Appendix I: PIC #3 Engagement Summary

Vaughan Metropolitan Centre (VMC) Transportation Master Plan (TMP)

PIC #3 Engagement Summary

Transit Network Map

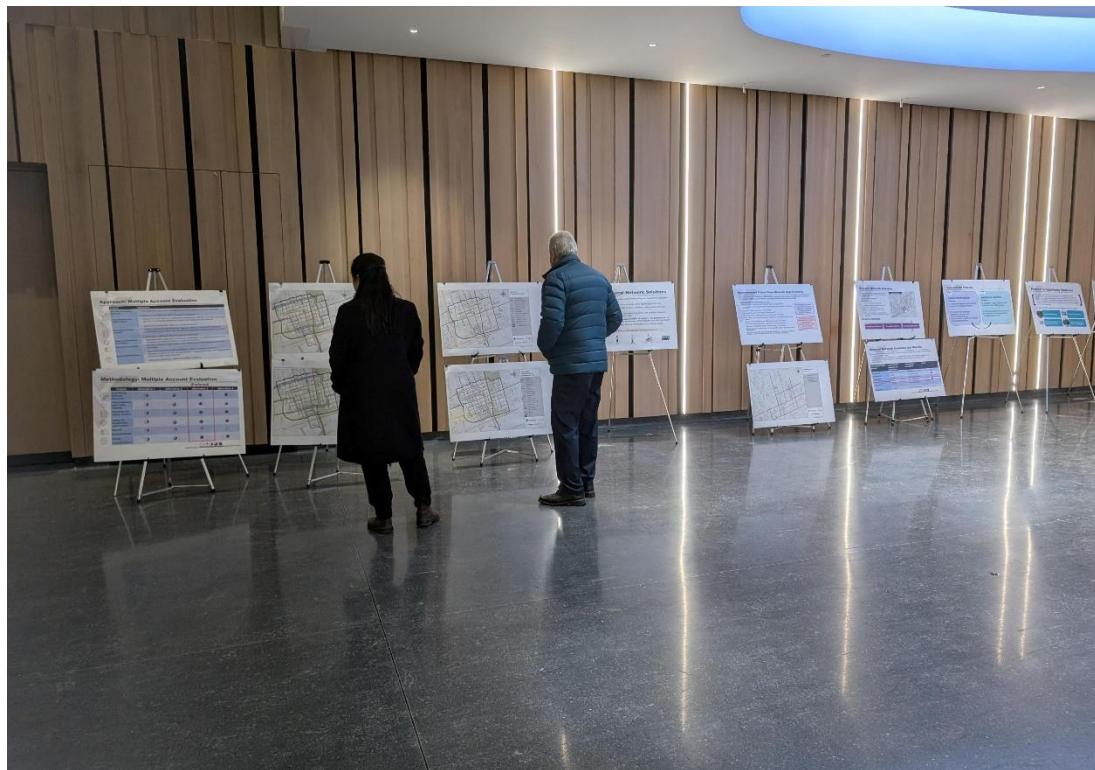
- Terminate Jane St BRT at Hwy 7 on Alternative 2, 3, and Transit Network maps.
- Include schools on maps according to the Secondary Plan to show where Transit is relative to schools.
- Add designated transit pickup and drop-off points on sections of New Park Place and Millway Avenue.
- Revise the alignment of the proposed interim transit circulator route to connect with Highway 407 station.

Alternative 3: Enhanced Network Improvements

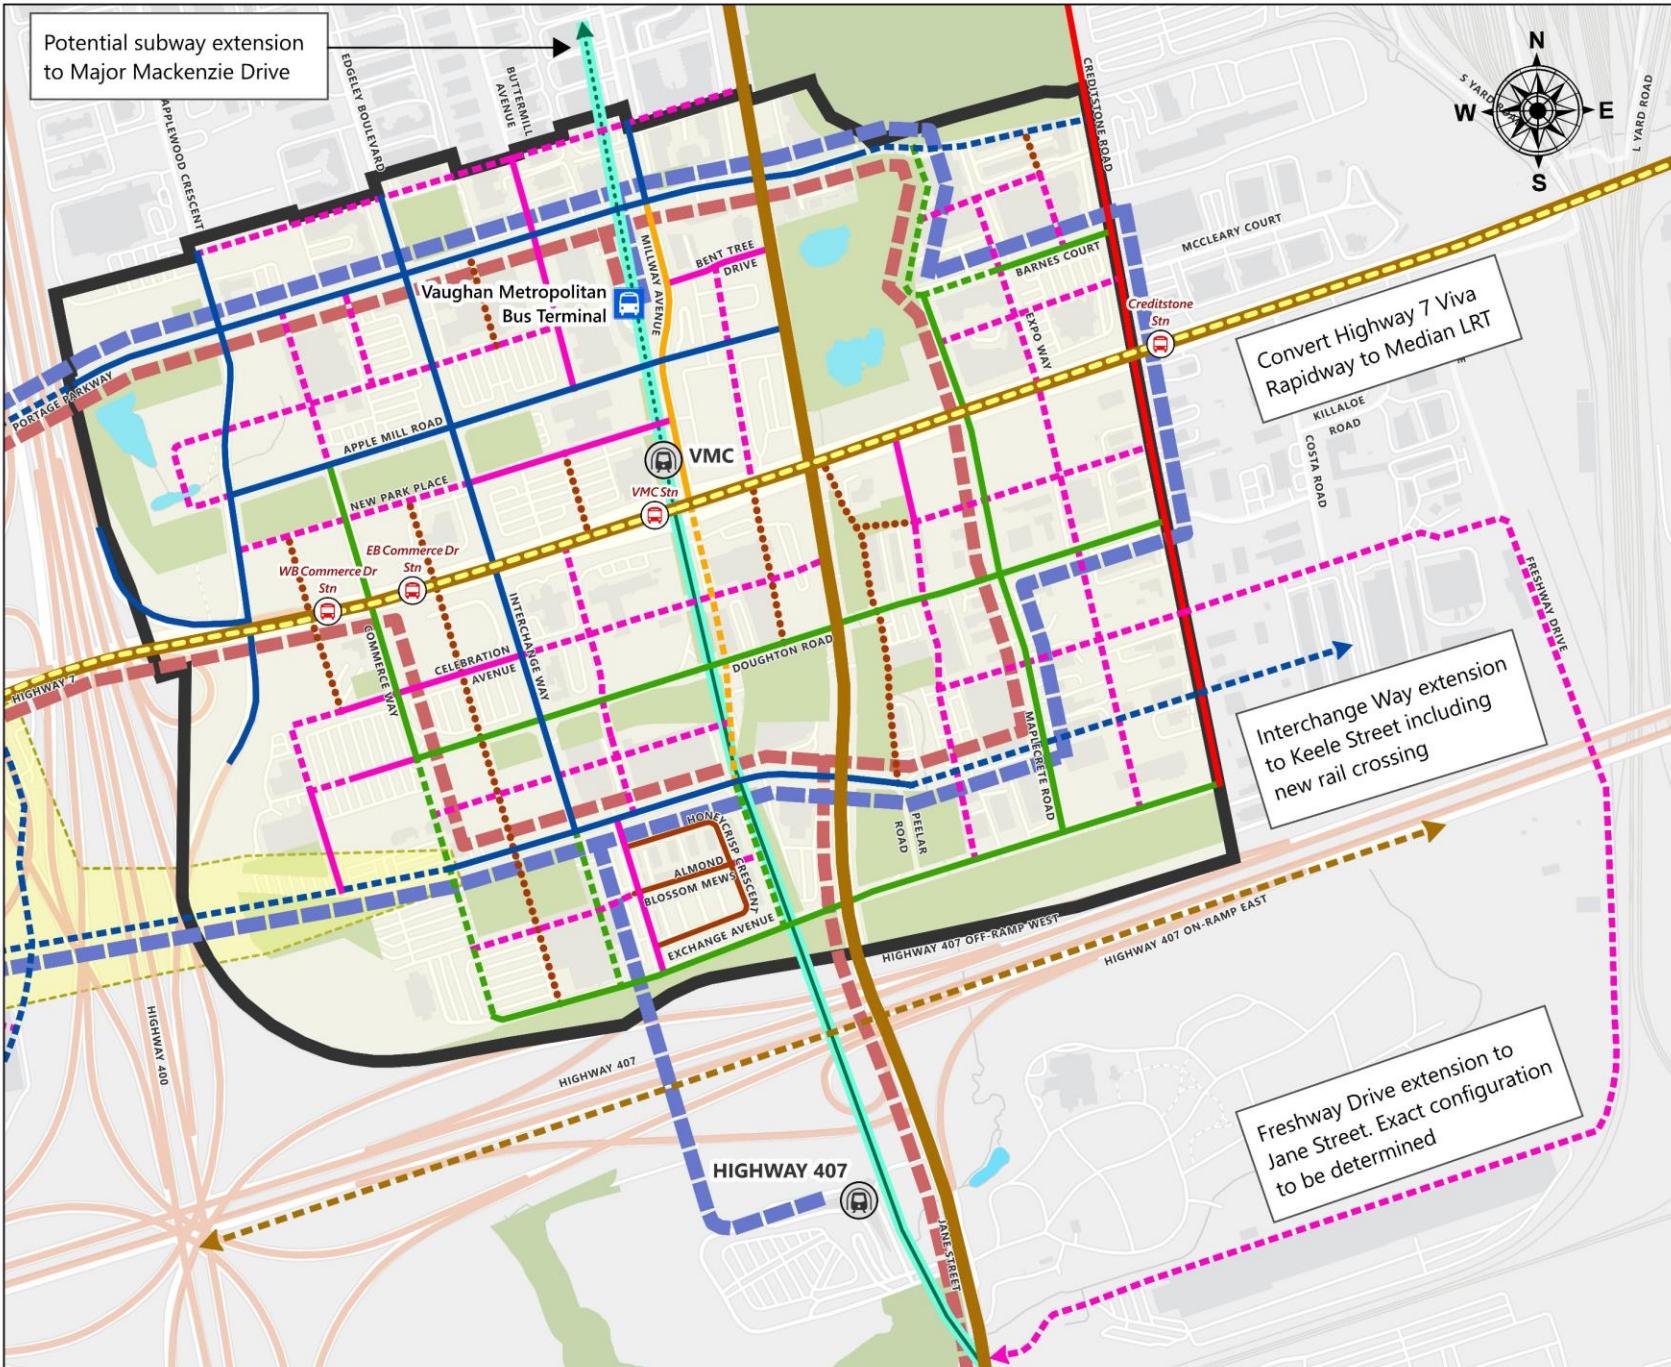
- The maps for 'Alternative 3: Enhanced Network Improvements' and 'Alternative 4: Infrastructure-Intensive Network Improvements' include 'Proposed Interim Transit Circulator Route' and 'Proposed Ultimate Transit Circulator Route'. It is recommended that the City consult with York Region Transit (YRT) staff to ensure alignment with YRT plans.

- The final report should identify the estimated costs for the pedestrian and transit crossings of Highway 400 and Highway 407, as outlined in both Alternative 3 (Enhanced Network) and Alternative 4 (Infrastructure Intensive Network).

VMC Active Transportation Network

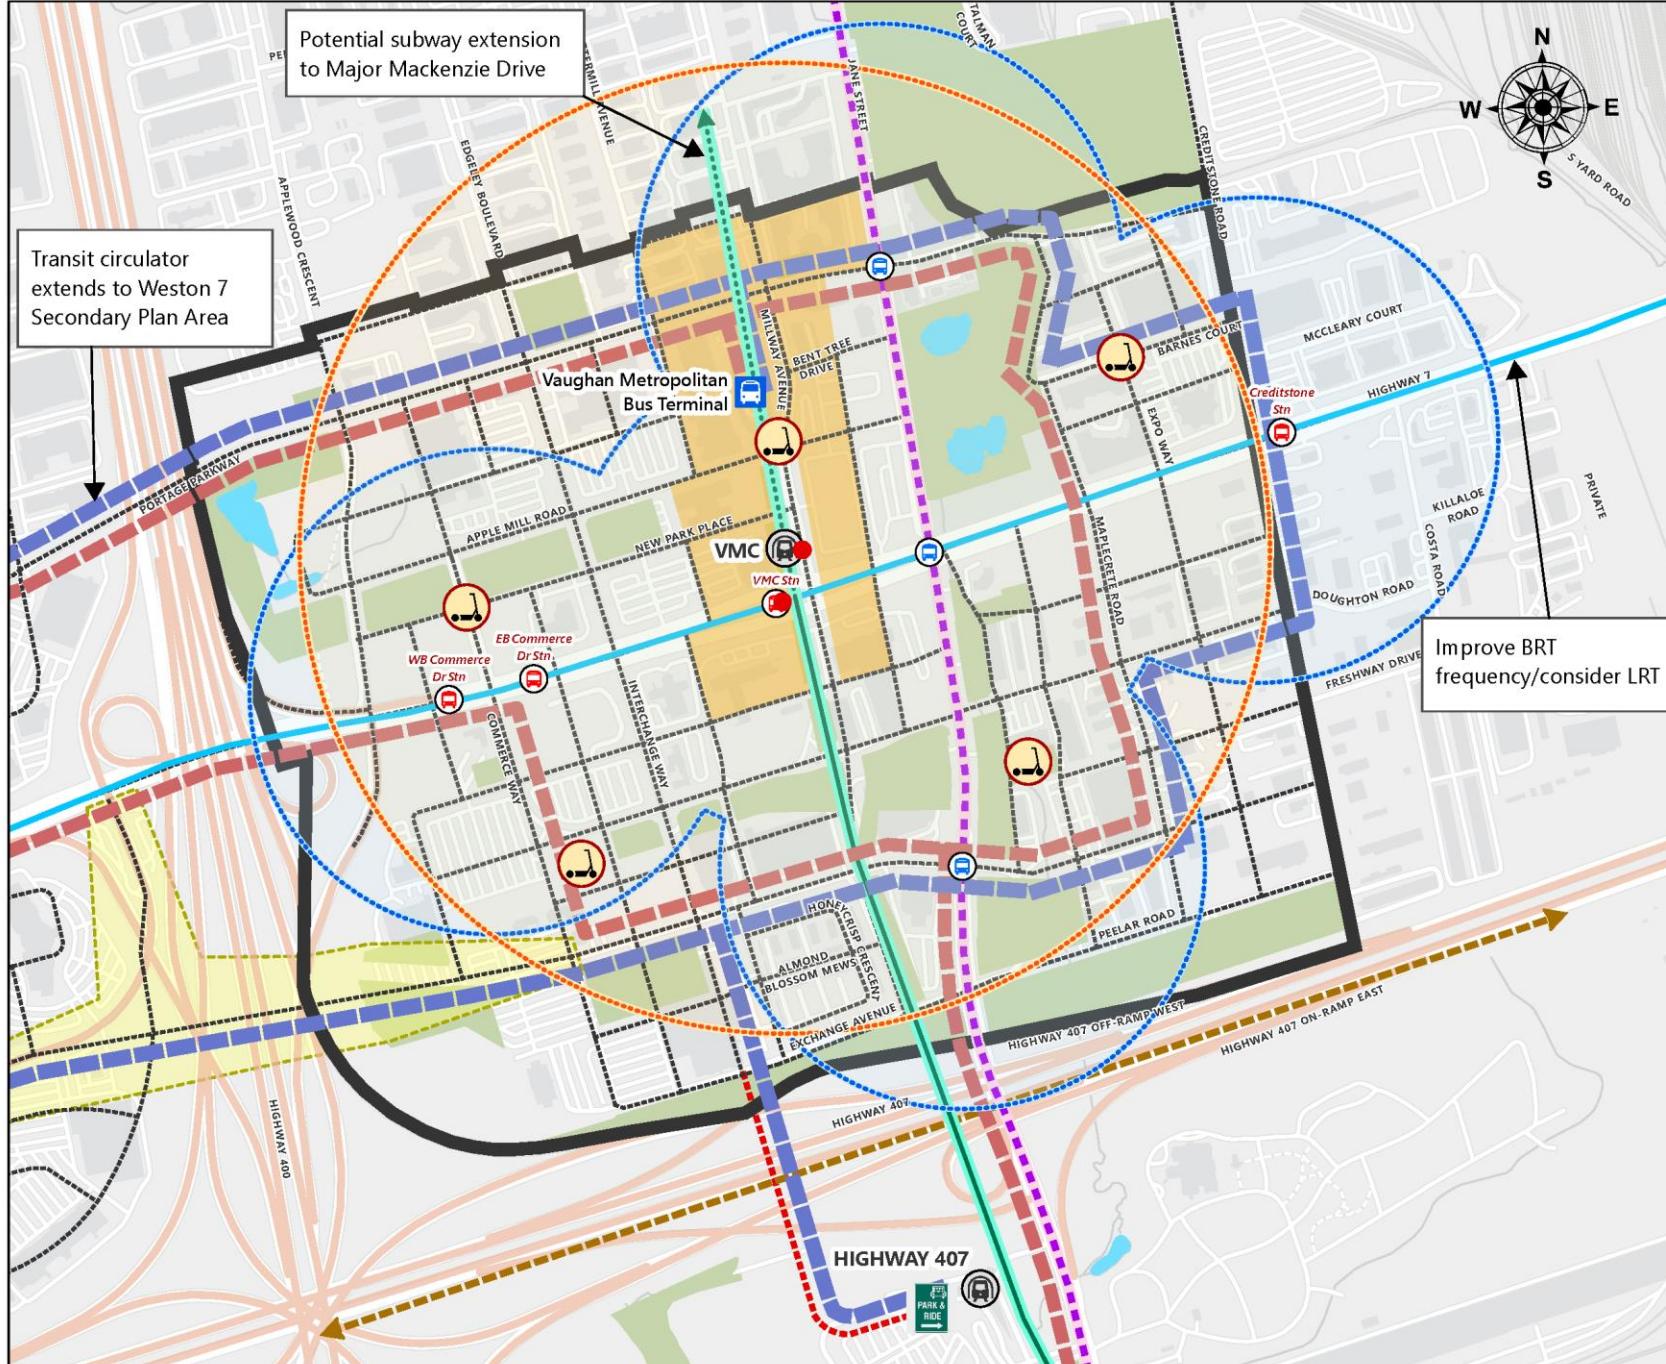
- Bylaws and policies should encourage similar parking considerations for employment and retail land uses in the VMC.
- The active network plans should be updated to show how the active transportation network connects to the York Region South York Greenway network, enhancing overall network connectivity.

- Incorporate South York Greenway into the Active Transportation Map.
- Include schools on maps according to the Secondary Plan to show where Active Transportation serves schools.
- Update parks on maps to reflect the latest Secondary Plan.
- Realign the Proposed Urban Space Loop from the Black Creek renewal using the most current CAD drawings.
- Incorporate the most up to date mews from the Secondary Plan.
- Add proposed Active Transportation Grade Separated Crossing on Hwy 7.
